ADDENDUM NO.: THREE

DATE OF ADDENDUM: January 12, 2016

**NEW MANUFACTURING TECHNOLOGY CENTER
ASNUNTUCK COMMUNITY COLLEGE
170 ELM STREET
ENFIELD, CT
BI-CTC-488**

SKETCH TITLE DELETED TREE

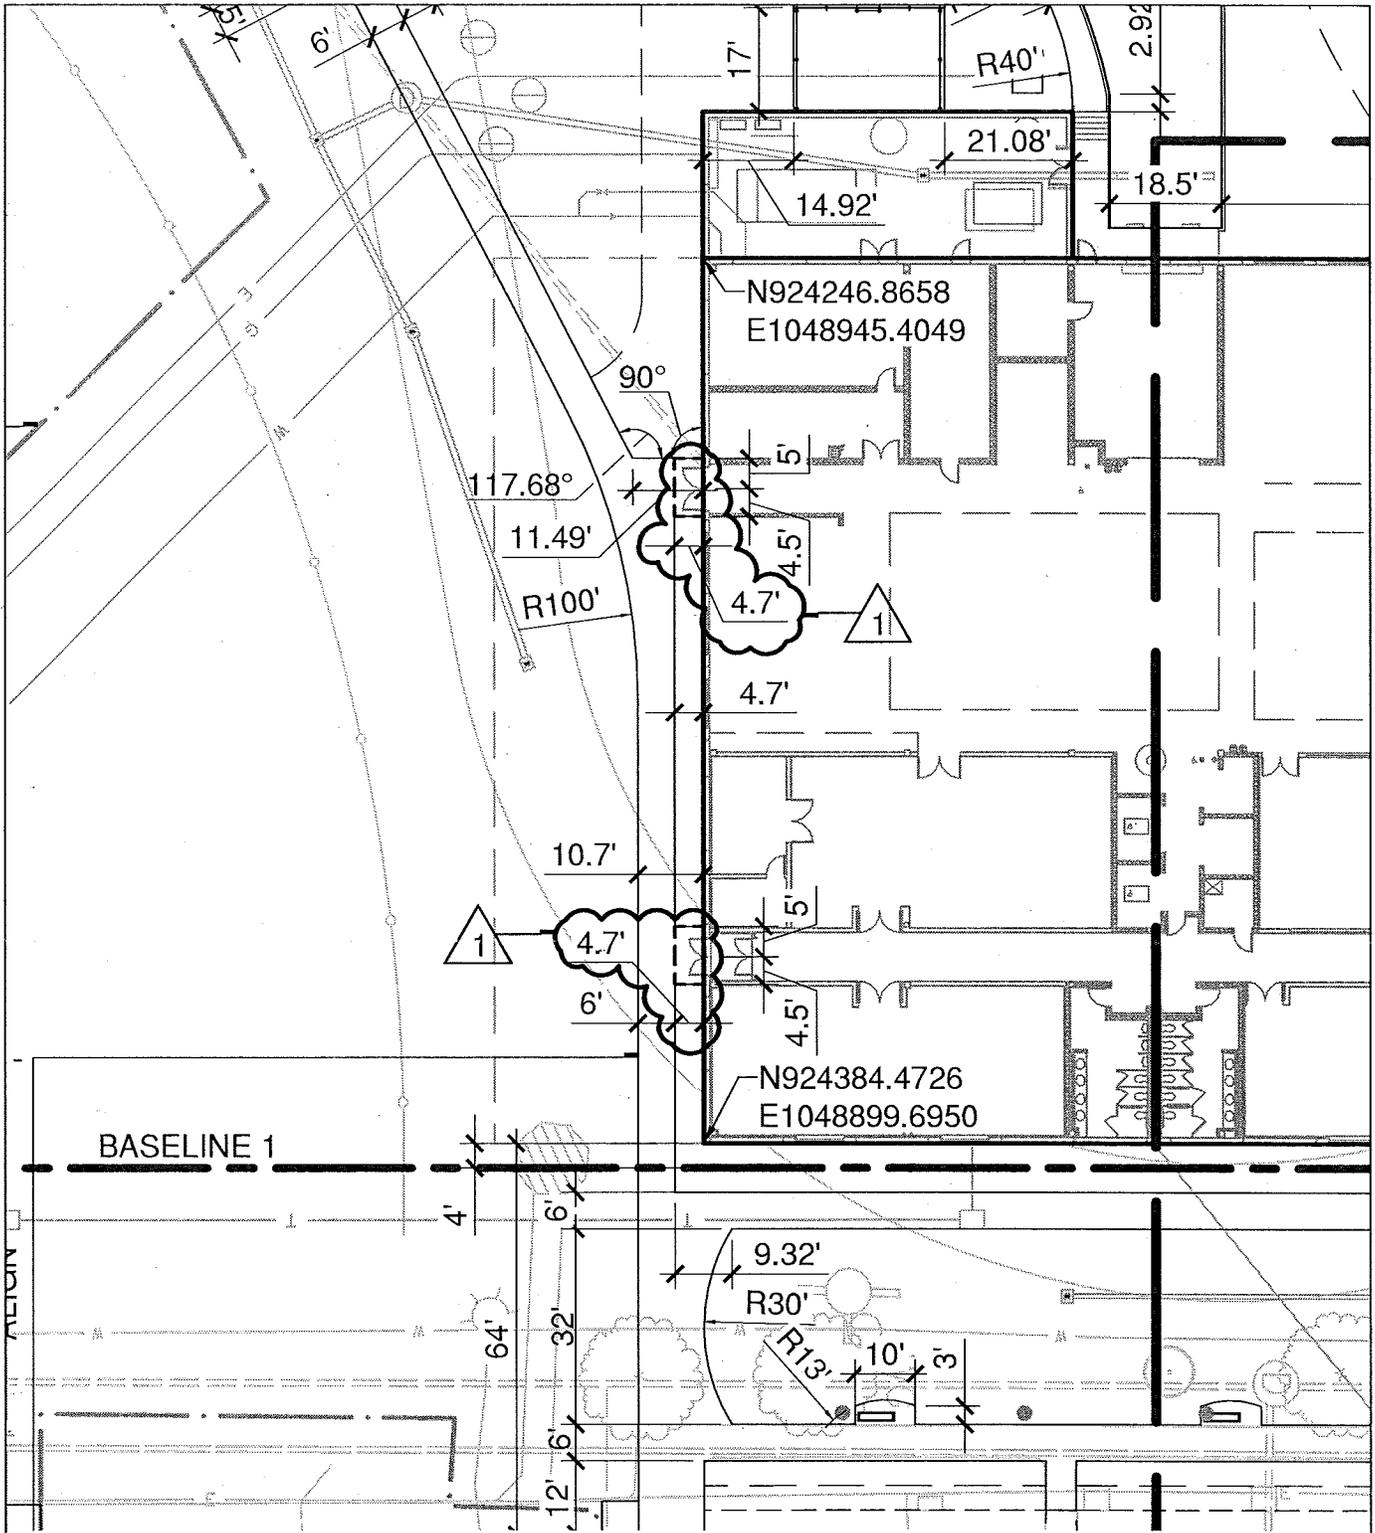
DRAWING L1.0 – SITE ILLUSTRATIVE PLAN: DELETE one (1) tree as shown by attached sketch AD3-SK-L1.0-2 titled "DELETED TREE" dated 01/11/2016.

SKETCH TITLE **FROST PAD DIMENSIONS REVISED**

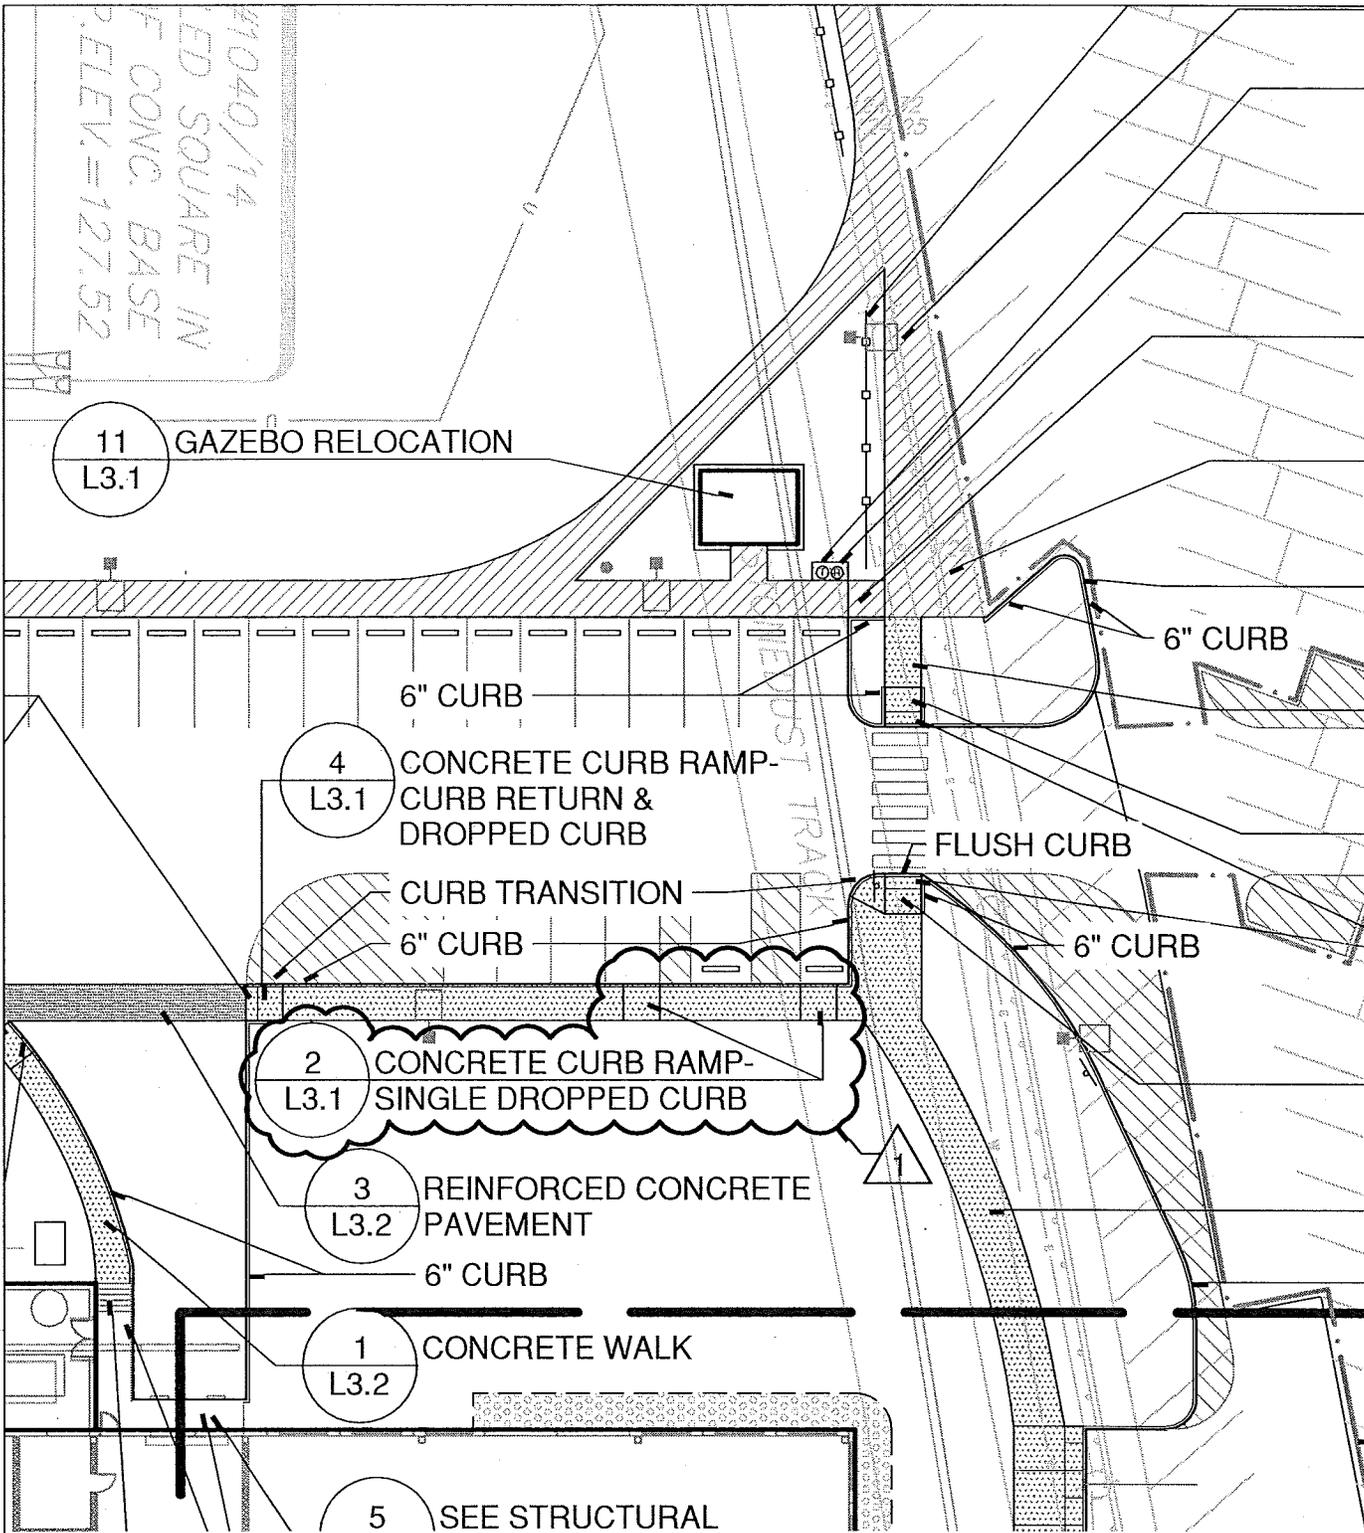
DRAWING L1.1 – SITE LAYOUT PLAN: REVISE plan to adjust size of east entrance frost pads and associated dimensions as shown by the attached sketch AD3-SK-L1.1-2 titled "FROST PAD DIMENSIONS REVISED" dated 01/11/2016.

SKETCH TITLE
RELOCATED HC PARKING SPACES

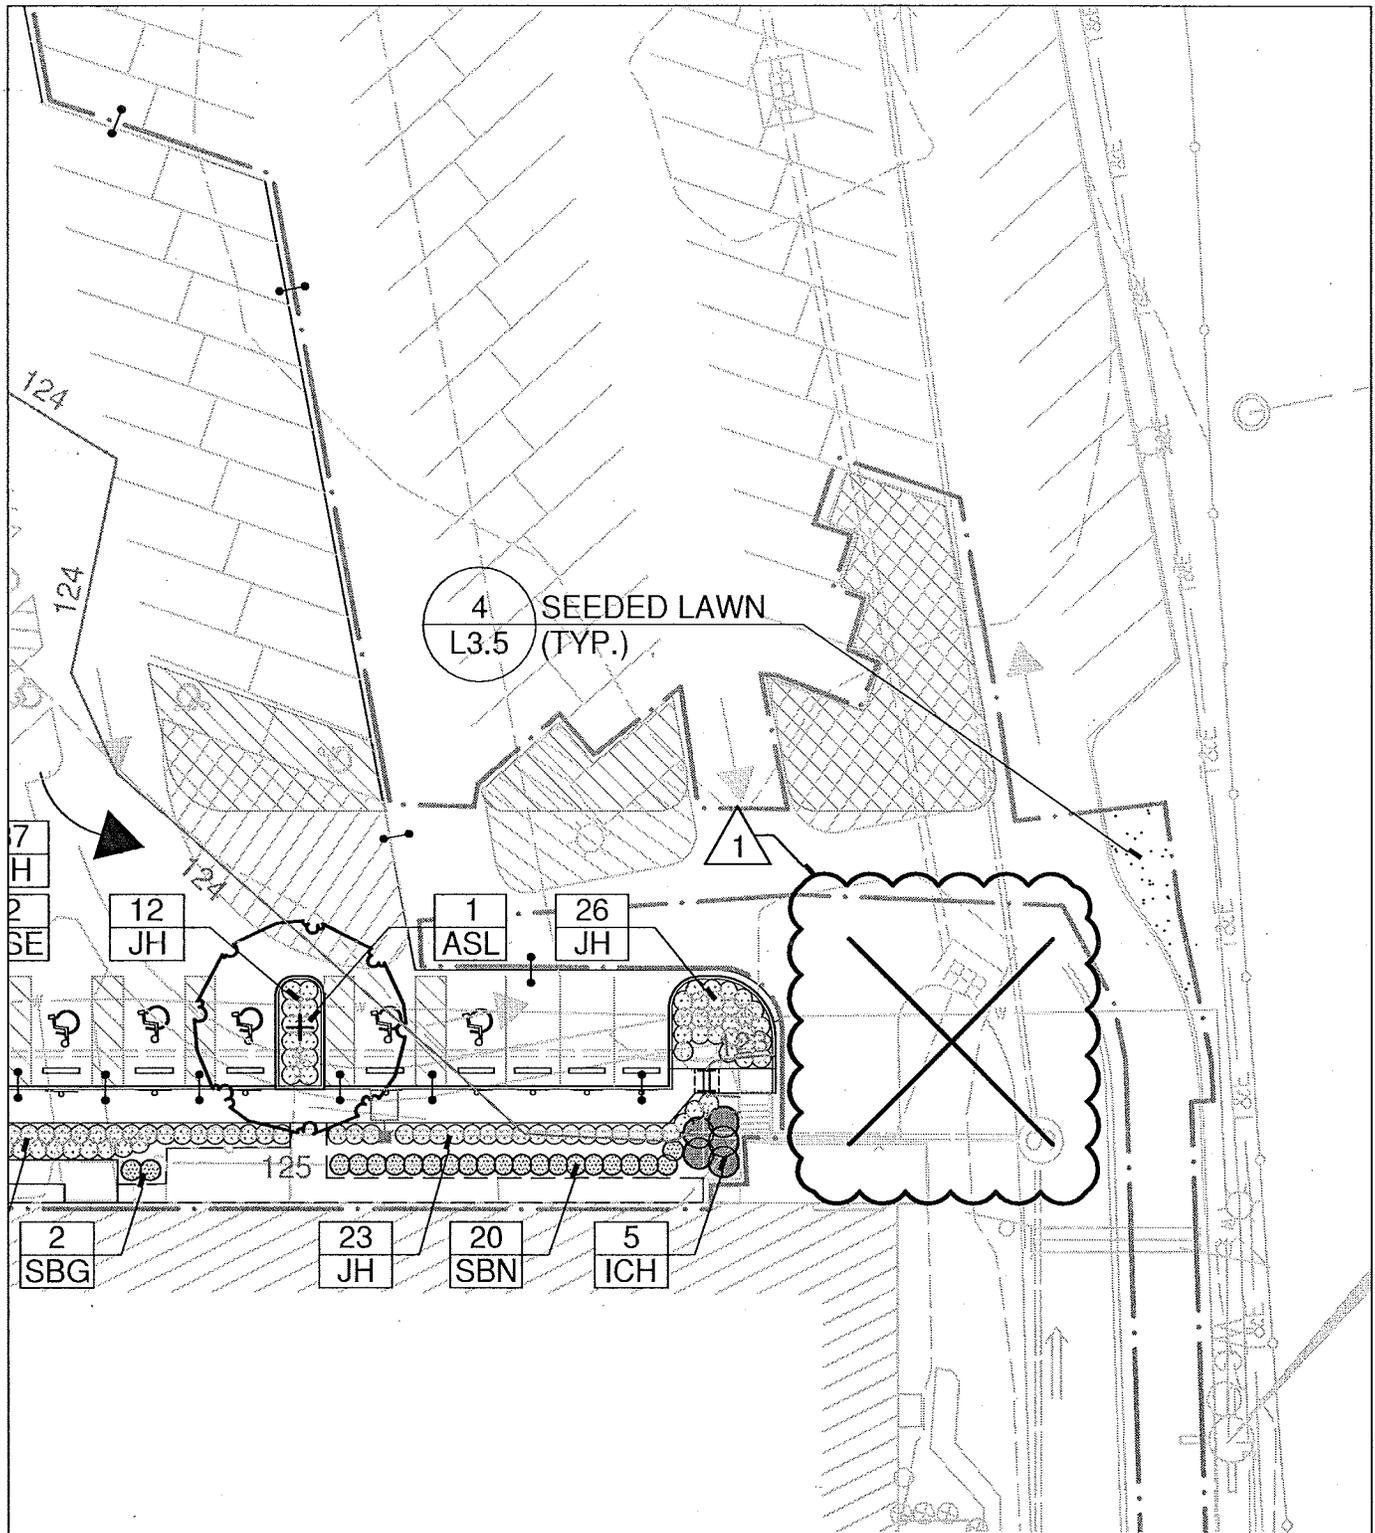
DRAWING L1.2 – SITE IMPROVEMENTS PLAN: REVISE plan to relocate two (2) HC Accessible Parking Spaces and associated material call outs as shown by attached sketch AD3-SK-L1.2-1 titled "RELOCATED HC PARKING SPACES" dated 01/11/2016.

4 CHAIN LINK FENCE W/ PRIVACY SLATS
N.T.S.

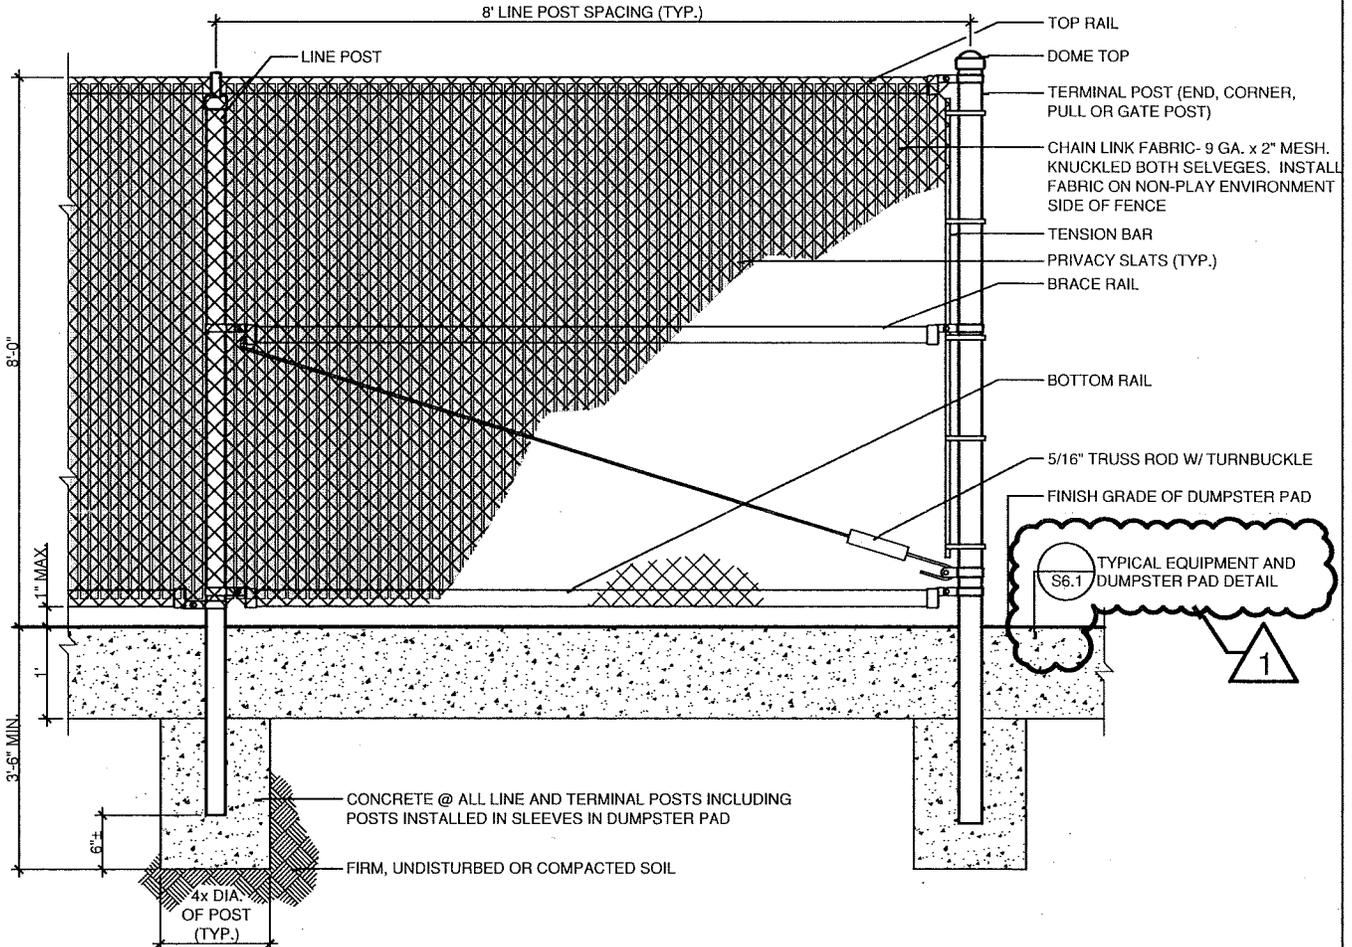
DRAWING L3.4 – SITE DETAILS: DETAIL 4 – CHAIN LINK FENCE W/PRIVACY SLATS DELETE call out to DETAIL 2 DUMPSTER PAD on SHEET L-3.4 and REPLACE with call out to DETAIL TYPICAL EQUIPMENT AND DUMPSTER PAD DETAIL on SHEET S6.1 as shown by attached sketch AD3-SK-L3.4-1 titled "CHAIN LINK FENCE W/PRIVACY SLATS" dated 01/11/2016.

NOTE:
PROVIDE SLEEVES FOR INSTALLATION
BY DUMPSTER PAD INSTALLER

13
A3.3 SCALE: 3/4"=1'-0"

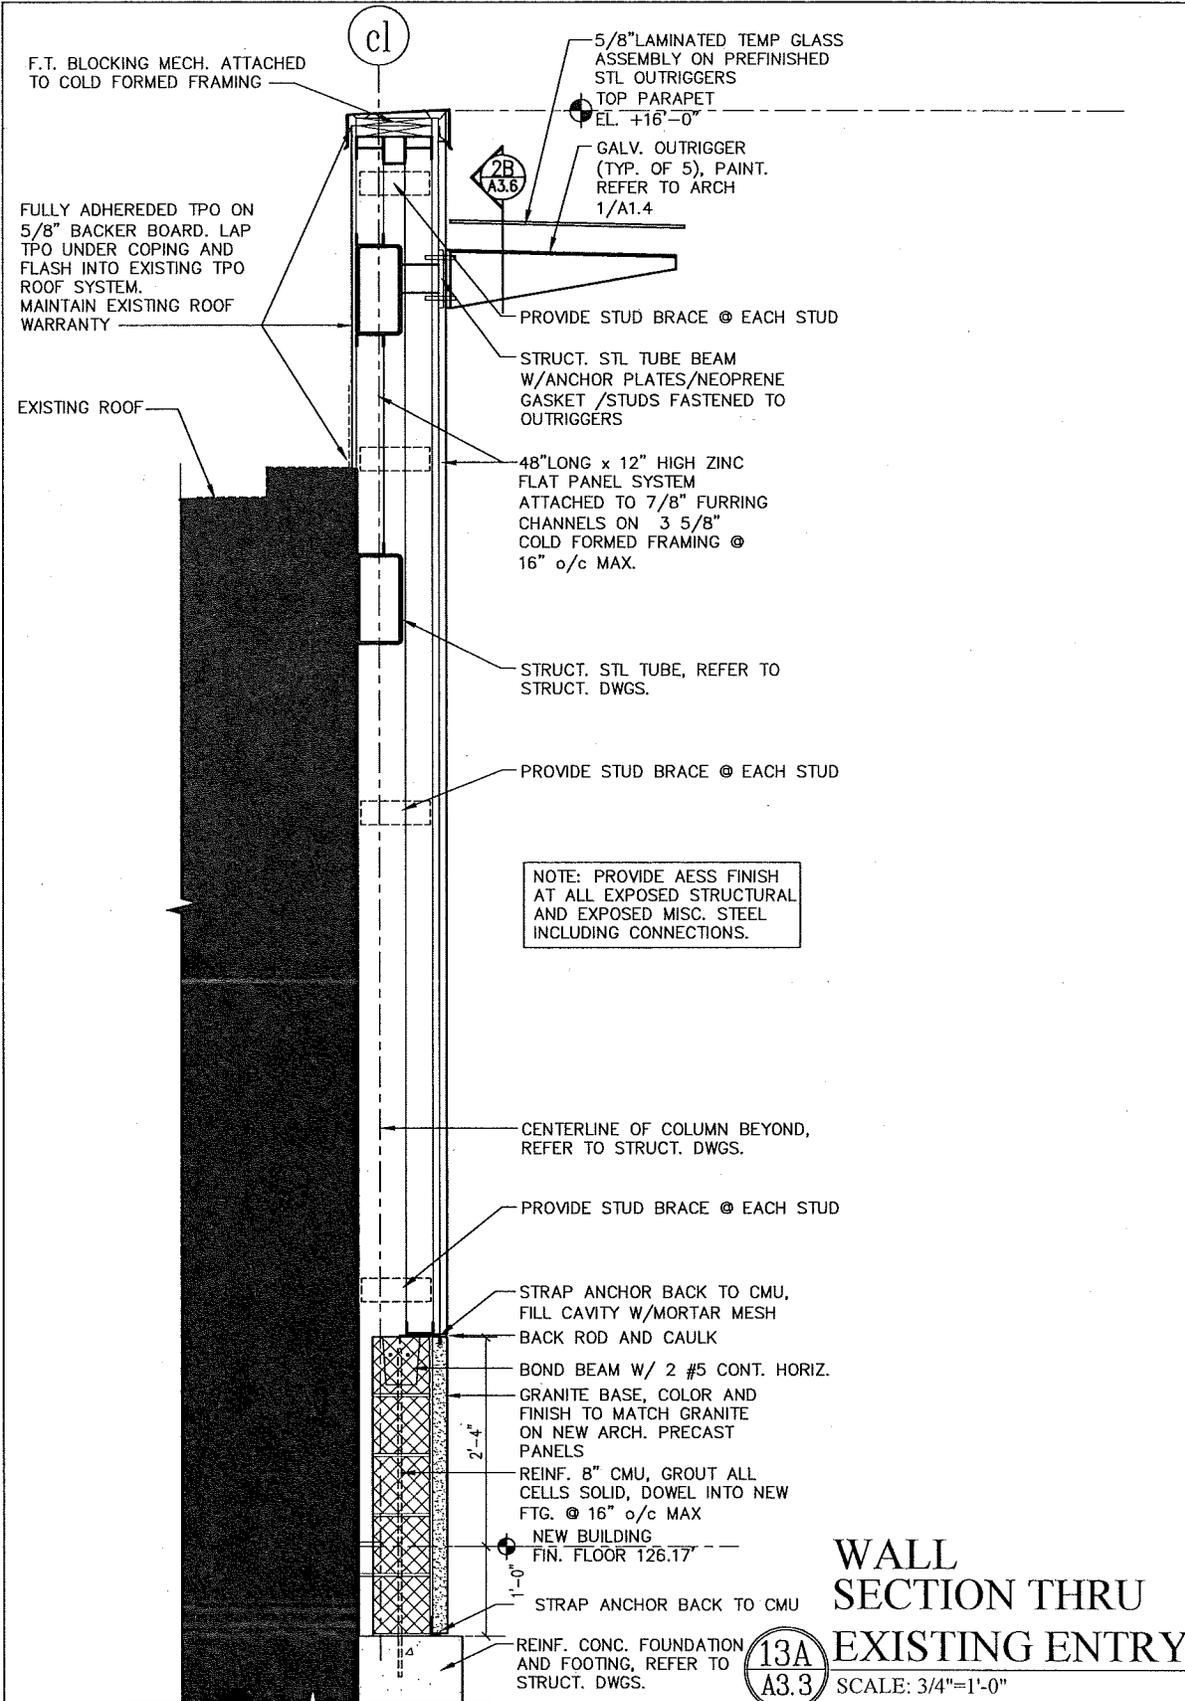
1. **DELETE** Section 13/A3.3 and **REPLACE** with new Section 13/A3.3 as shown by attached sketch AD3-SK-A3.3.1 dated 1/11/2016.
2. **DELETE** Section 13A/A3.3 and **REPLACE** with new Section 13A/A3.3 as shown by attached sketch AD3-SK-A3.3.2 dated 1/11/2016.

NOTE: PROVIDE AESS FINISH AT ALL EXPOSED STRUCTURAL AND EXPOSED MISC. STEEL INCLUDING CONNECTIONS.
